## Accessibility Audit Report

# Ringsend to City Centre Core Bus Corridor Scheme

## Accessibility Audit Report

**Ringsend Park Access Arrangement**

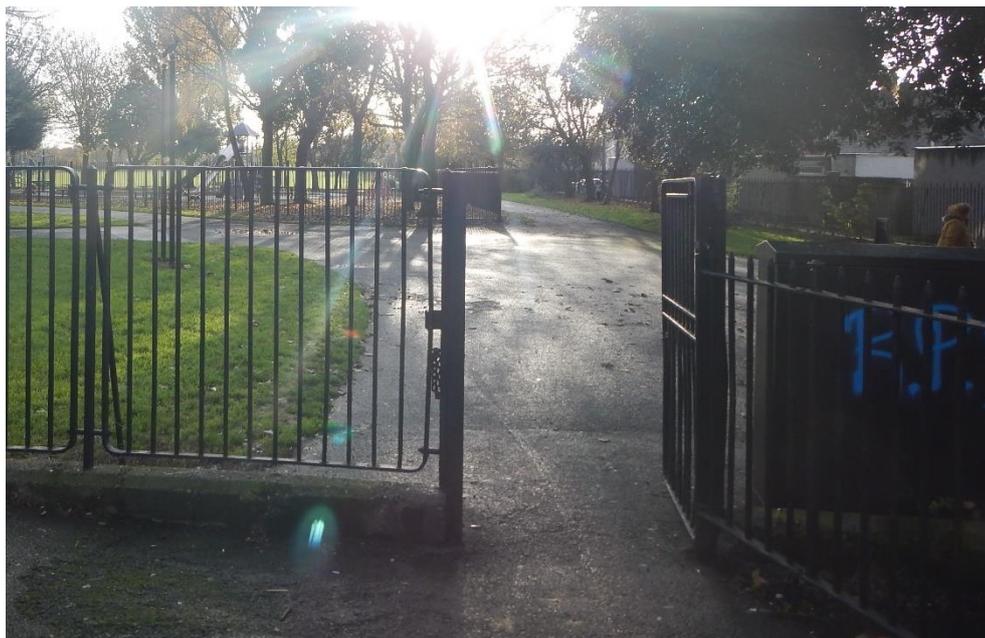
The existing access gates in Ringsend Park are constrained, particularly for both cyclist and pedestrian use. Constrained access arrangements similar to the image below create a high risk of collision between cyclists and pedestrians, in particular visually impaired pedestrians reliant on a cane or guide-dog. Improved permeability should be considered at these constrained locations to minimise the interaction between cyclists and pedestrians and prevent any risk of collision between these users.

The width of the path through Ringsend Park is also insufficient for shared pedestrian and cycle use. A narrow shared path can lead to conflict between vulnerable pedestrians and fast moving cyclists and should be avoided where possible. Full segregation should be considered with careful consideration of any resultant criss-crossing manoeuvres that may manifest from the implementation of full segregation of cyclists and pedestrians.

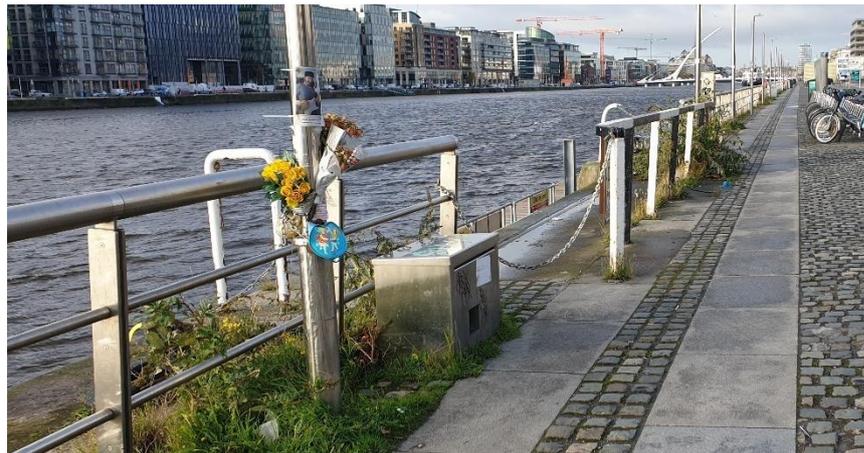
Fallen leaves were also noticed in certain areas along the pedestrian routes, particularly at the Dublin Docklands building. Fallen leaves can become saturated with rainwater and are a serious slip hazard when wet. The location of the leaves, towards the back of the path, is in line with the preferred path of visually impaired cane assisted pedestrians who tend to prefer walking close to the back of the path. Regular cleaning of the pedestrian routes, particularly where located next to deciduous trees, will be required and any landscaping plans to be cognizant of proposed tree types next to footpaths.

### Discrepancies in Hazard Tactile Paving provision

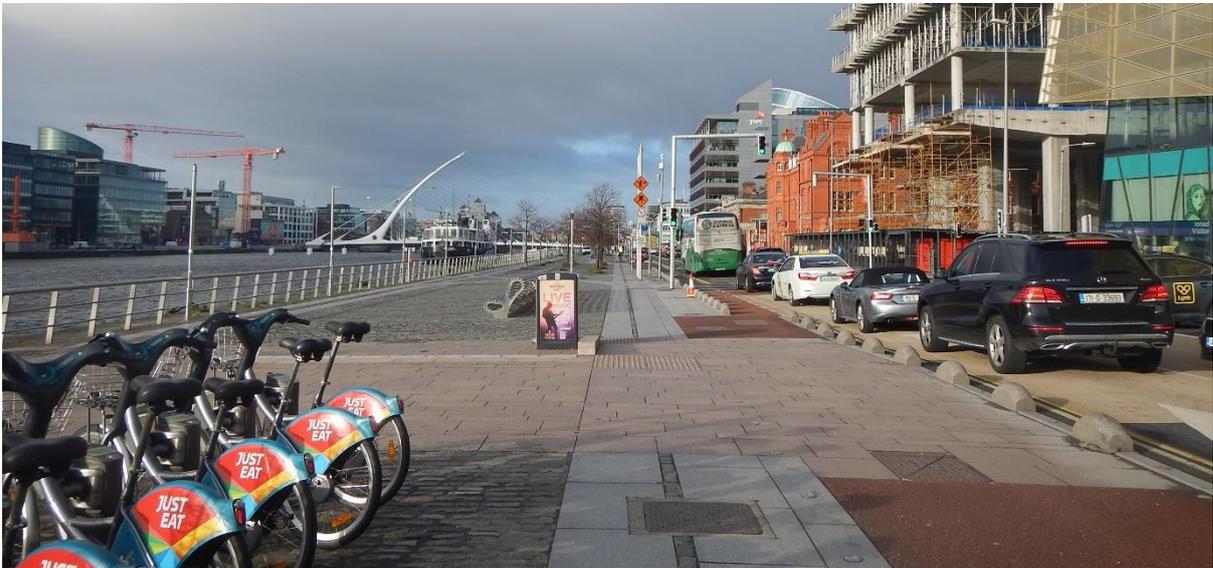
The few instances where segregated bicycle tracks meet the footpath to share facilities [along North Wall Quay to Samuel Beckett bridge, and near Talbot Memorial Bridge] there is no corduroy and tramline tactile paving. The use of such paving can cause issues for all users however, such as water freezing in the grooves causing a slip hazard, therefore improved segregation should be considered first before accepting the current shared arrangement and adding such tactile paving.

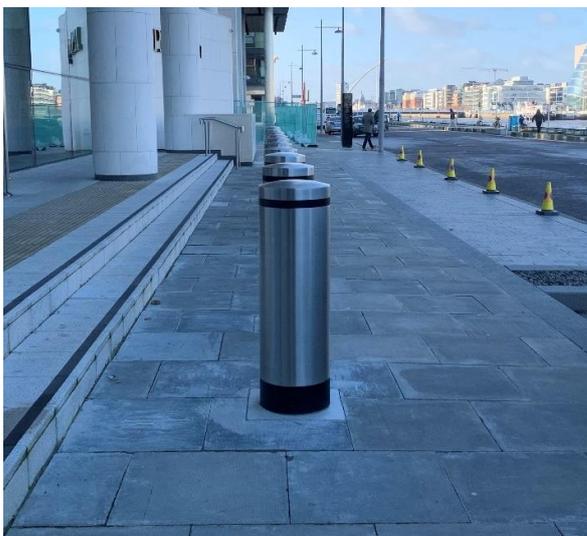
One on-street disabled parking space was identified during the walking audit to the east of Samuel Beckett Bridge, in an indented bay between Asgard Road and Blood Stoney Road. The parking space appears to be 5m in length or less. This parking space appears to serve the general public rather than any particular patron. A disabled parking space shall be retained at this location, however it shall be demarcated to conform to the requirements of the Department of Transport’s Traffic Signs Manual.

**Ramps at crossing points with dished kerbs**

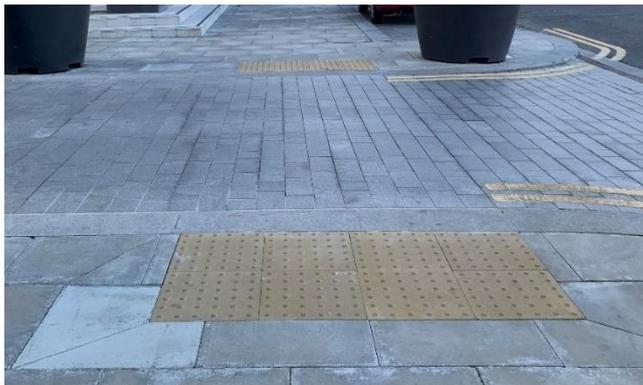
The side street crossings along the southern footpath east of the Samuel Beckett Bridge all incorporated dished kerbs or kerbs flush to raised platforms, of which most were appropriately located perpendicular to the line of travel and away from the curve of the road. At the controlled crossings on Forbes Street and Cardiff Lane, ramps were constructed in the road ramping down to meet the dished kerbs, which is unhelpful for wheelchair users in particular. If ramps are required at crossing points, they shall of uniform height across the line of travel, made flush with full height kerbs.

**Cobble lock used in lieu of blister tactile paving at uncontrolled crossings**

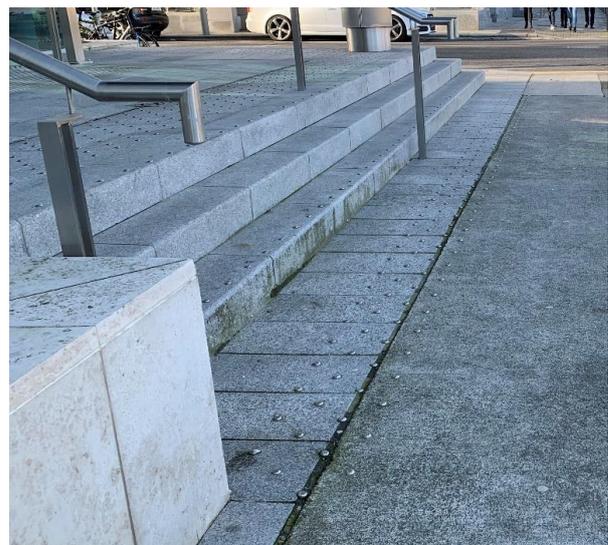
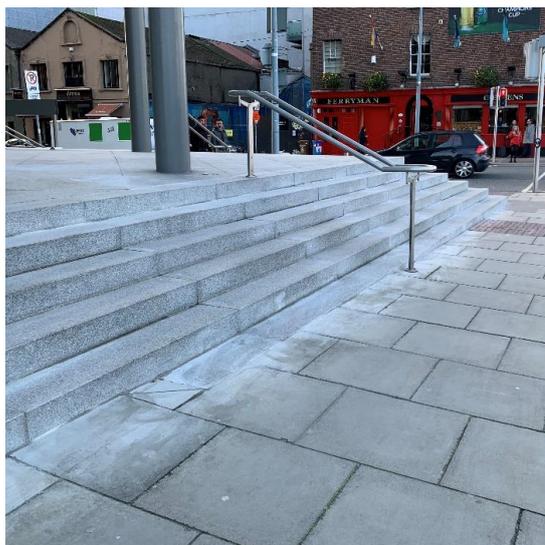
Red blister tactile paving has been provided at all controlled crossing points along the south quays, as is required. A significant number uncontrolled crossings do not have tactile paving at the dished kerbs. The existing buff coloured cobble lock used at these crossings should be replaced with buff colour blister tactile paving. Tactile paving shall be provided at all crossings as required by the crossing type, whether controlled [red blister] or uncontrolled [buff].

Project Title: <b>BUSCONNECTS INFRASTRUCTURE DUBLIN</b>			
Drawing Title: <b>ROUTE 16: RINGSEND TO CITY CENTRE ACCESSIBILITY AUDIT</b>			
Drawing File Name: BCIDD-ROT-PMG_PS-0016_XX_00-AU-CR-0001	Sheet Number: 01 of 10	Status: SO	Rev: K01

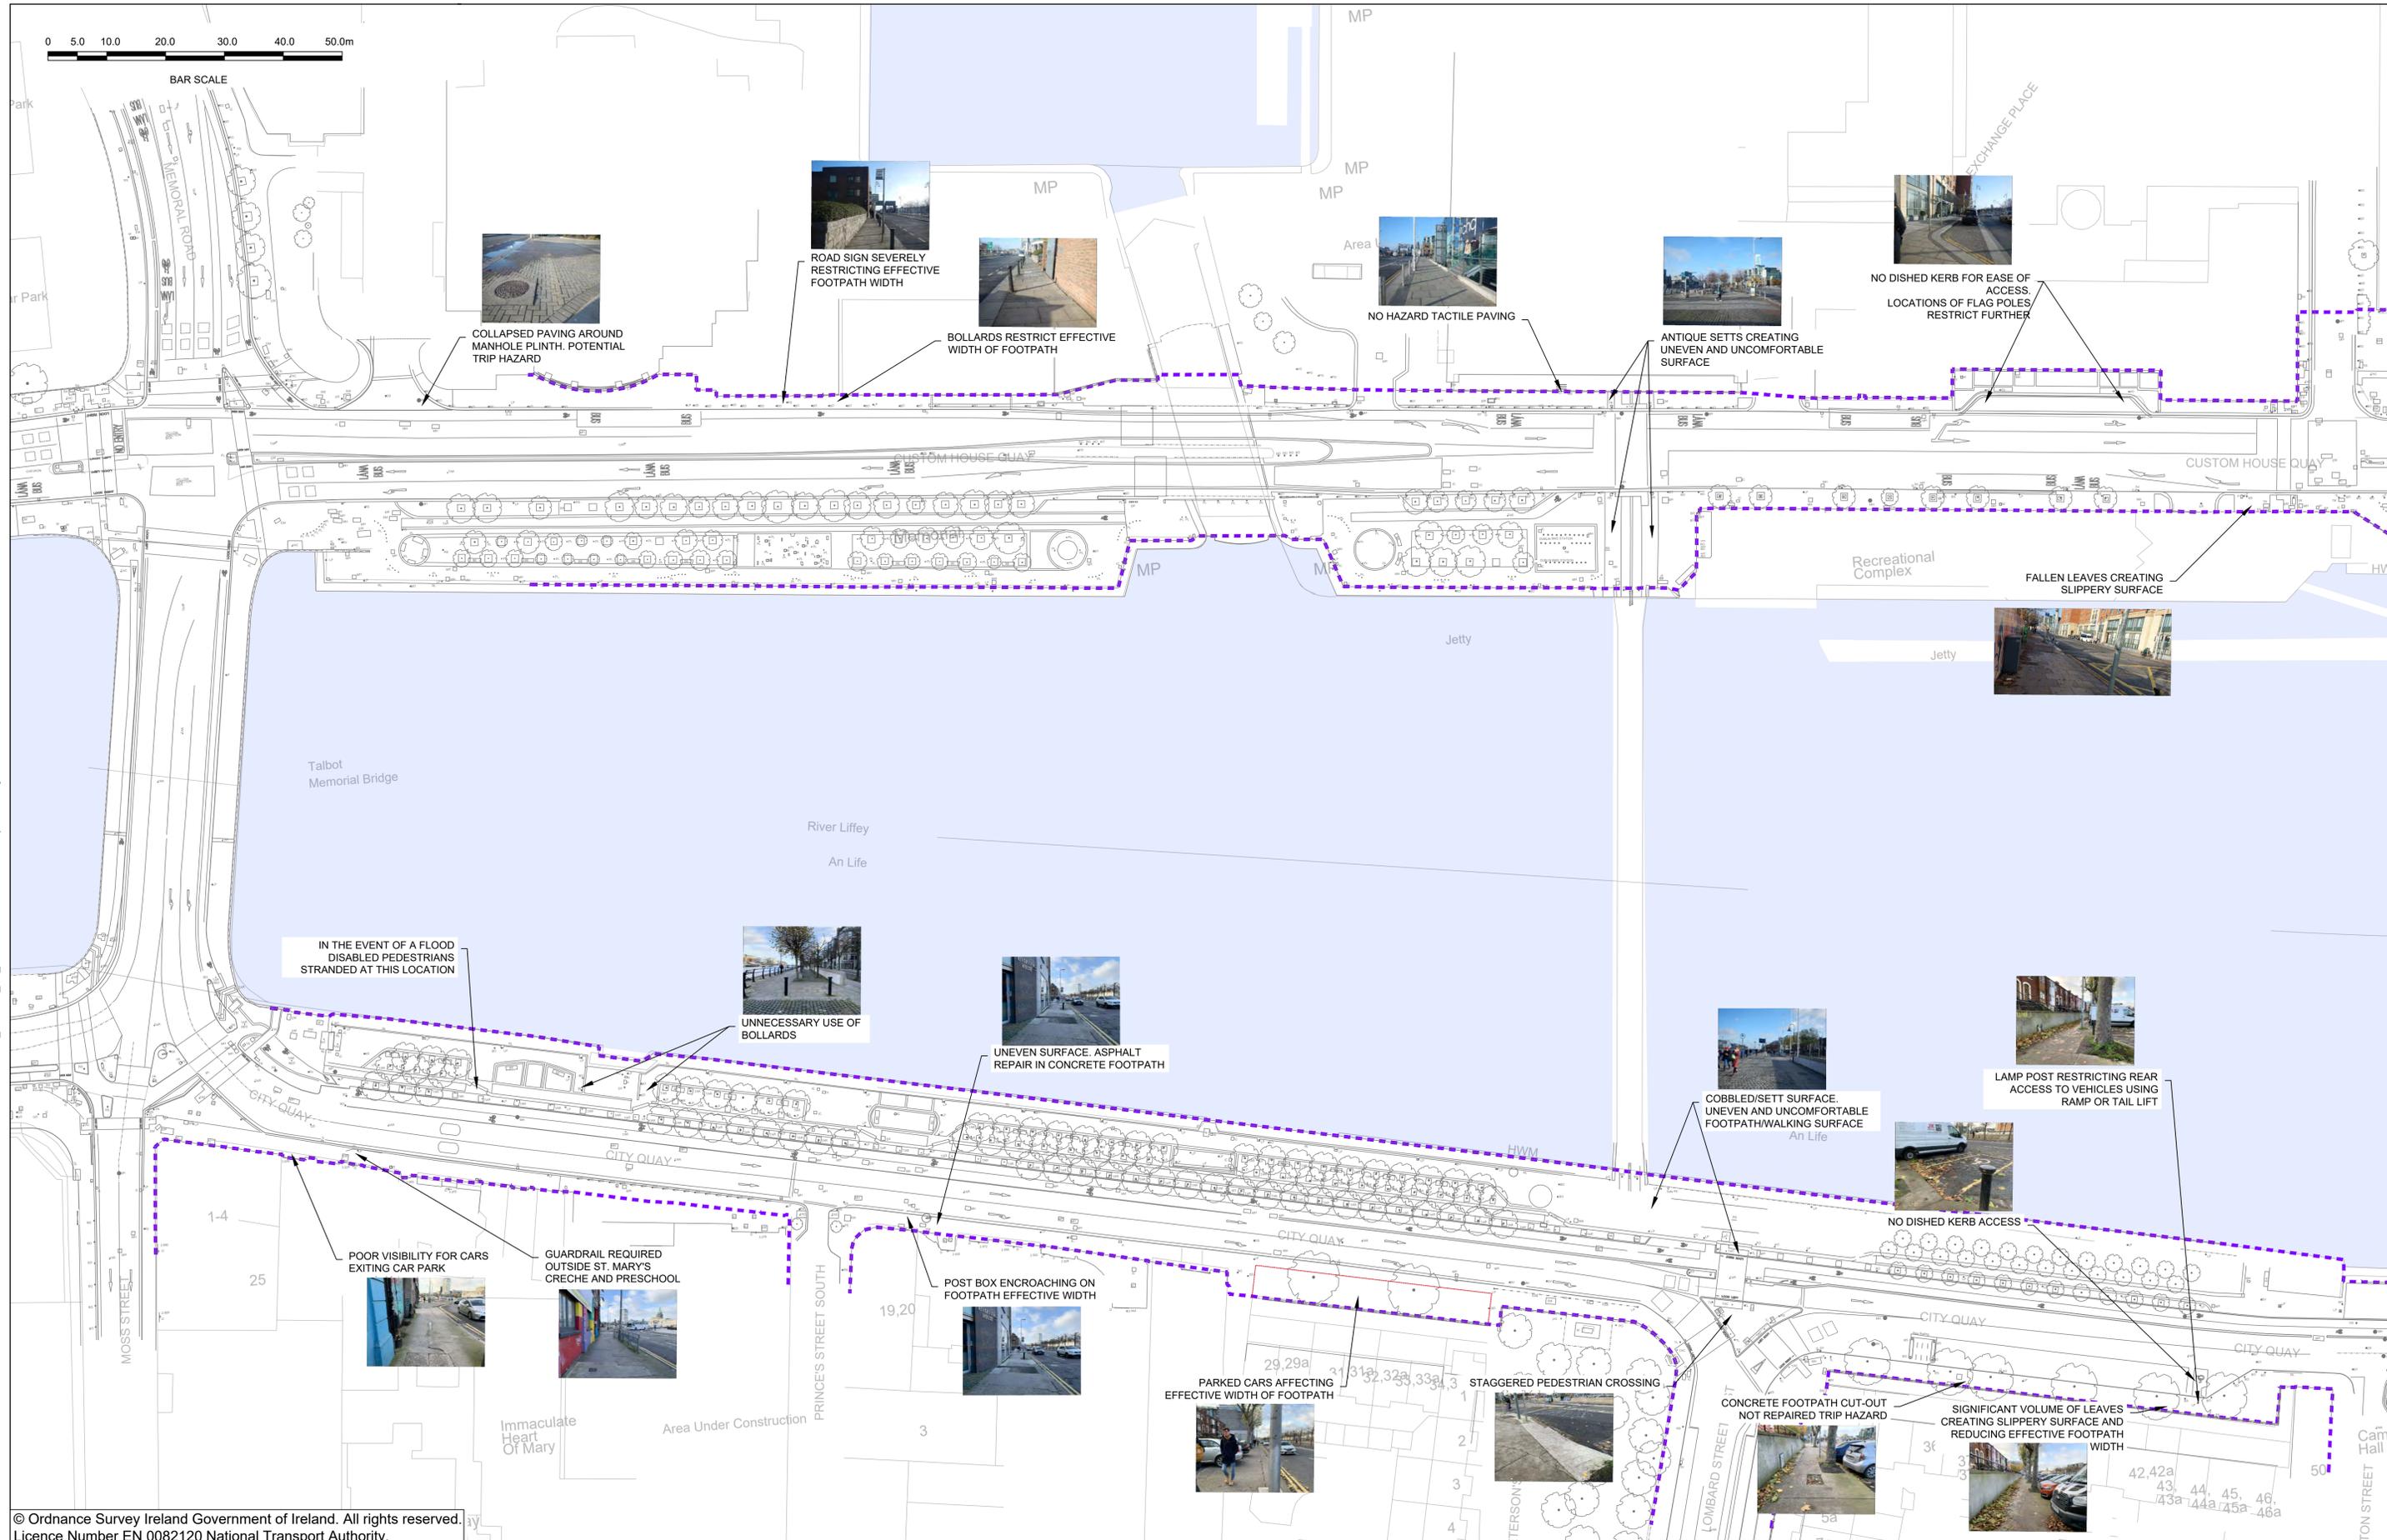
BCIDD-ROT-PMG_PS-0016_XX_00-AU-CR-0001	Fallen leaves can become saturated with rainwater and are a serious slip hazard when wet. The location of the leaves, towards the back of the path, is in line with the preferred path of visually impaired cane assisted pedestrians who tend to prefer walking close to the back of the path. Regular cleaning of the pedestrian routes, particularly where located next to deciduous trees, will be required and any landscaping plans to be cognizant of proposed tree types next to footpaths.	N/A	N/A	Outside of scope of Proposed Scheme
BCIDD-ROT-PMG_PS-0016_XX_00-AU-CR-0001	Along the campshire, particularly between the Talbot Memorial Bridge and Lombard Street, the flood wall encloses all footpath routes and no compensatory crossing facility is provided to the southern footpath, creating a disconnect for mobility and visually impaired pedestrians. This should be addressed to ensure that in the event the flood walls are closed to pedestrian traffic, that all pedestrians have a safe, direct means of travel along the south quays.	N/A	N/A	Outside of scope of Proposed Scheme

BCIDD-ROT-PMG_PS-0016_XX_00-AU-CR-0001	Cars exiting City Quay Car Park have poor visibility and the footpath pavement is not in good condition. It is recommended that priority be given to pedestrians across the access to reduce the level of uncertainty over priority on what appears to be footpath.	Yes	Yes	Footpath and pedestrian crossing the parking entrance will be reconstructed as part of the works. Adequate surface treatment will be reviewed during Detailed Design
BCIDD-ROT-PMG_PS-0016_XX_00-AU-CR-0001	The design shall replace the guardrail outside St Mary's Creche & Preschool for the safety of all children exiting the building.	Yes	N/A	The St Marys Creche & Preschool is permanently closed and the need for the guardrail will be assessed again during the detailed design process but should a childrens facility no longer have an active function in the building, the guardrail will no longer be required at this location.

BCIDD-ROT-PMG_PS-0016_XX_00-AU-CR-0001	The presence of cars parked near the apartment building affects the effective width of the footpath and restricts the passage of pedestrians.	Yes	Yes	This will be reviewed during Detailed Design
BCIDD-ROT-PMG_PS-0016_XX_00-AU-CR-0001	Staggered pedestrian crossing. This arrangement increases the crossing distance particularly for vulnerable pedestrians. The island also results in a constrained dwell area for potentially high volumes of pedestrians. The layout of the junction should be revised as part of the scheme to remove the staggered crossing, thereby improving the overall crossing facility and the dwell space at footpaths, and decreasing the required crossing distance.	Yes	Yes	Junction layout updated, removing the central island and realigning pedestrian crossings.
BCIDD-ROT-PMG_PS-0016_XX_00-AU-CR-0001	Cobbles and setts create an uneven and uncomfortable surface to walk on and may present a trip hazard.	Yes	Yes	Pavement types will be reviewed during Detailed Design
